2018 Mercedes Benz E63S AMG 4MATIC Sed (213.089) V8-4.0L Turbo (177.980)

SEAT CUSHION FORE/AFT ADJUSTER SEAT CUSHION COVER BECOMES DETACHED

Topic number	LI91.18-P-049463
Version	3
Function group	91.18 Seat covers
Date	07-31-2018
Validity	BR204 and 207 with SA code 409 (Multicontour seat) and BR212 with SA code 409/432 (Multicontour seat/active multicontour seat) BR 205 and 213 with SA code P65 (Seat cushion fore/aft adjustment) and with 275 (Electrically adjustable driver seat with memory function) or 241 (Electrically adjustable front seats) or 242 (Electrically adjustable front passenger seat with memory function)
Reason for change	BR213 added

P1040937

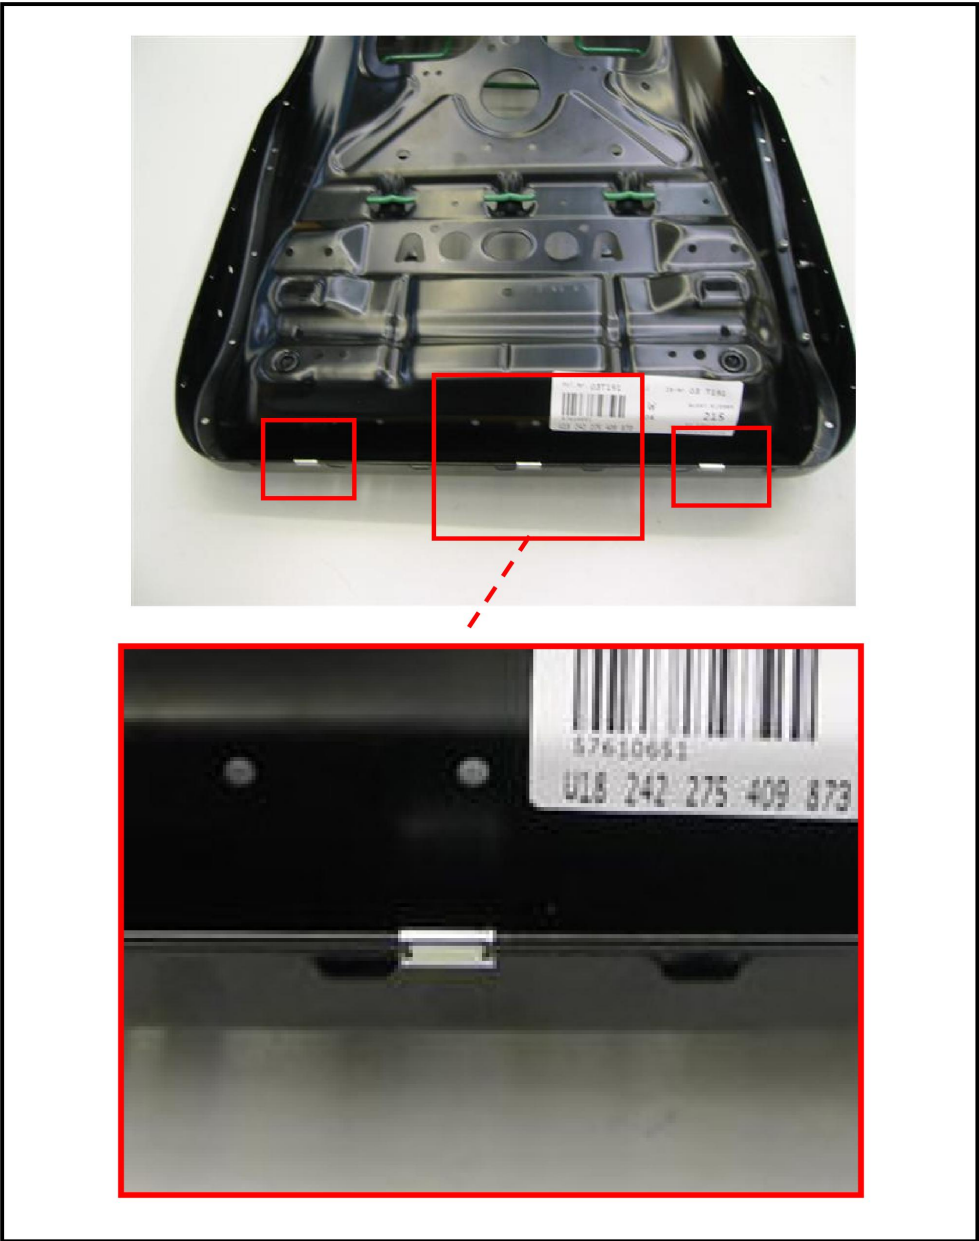
- Model series 204 and 212: Insufficient holding ability of the fastening strip
- Model series 207: Matting incorrectly positioned. (See picture P1040937)
- Model series 205 and 213: Insufficient holding ability of the fastening strip

Designation
Matting trapped in profile

! Remove the folded matting from the fold, reattach the cover accurately and make sure that the fastener clicks firmly into place !
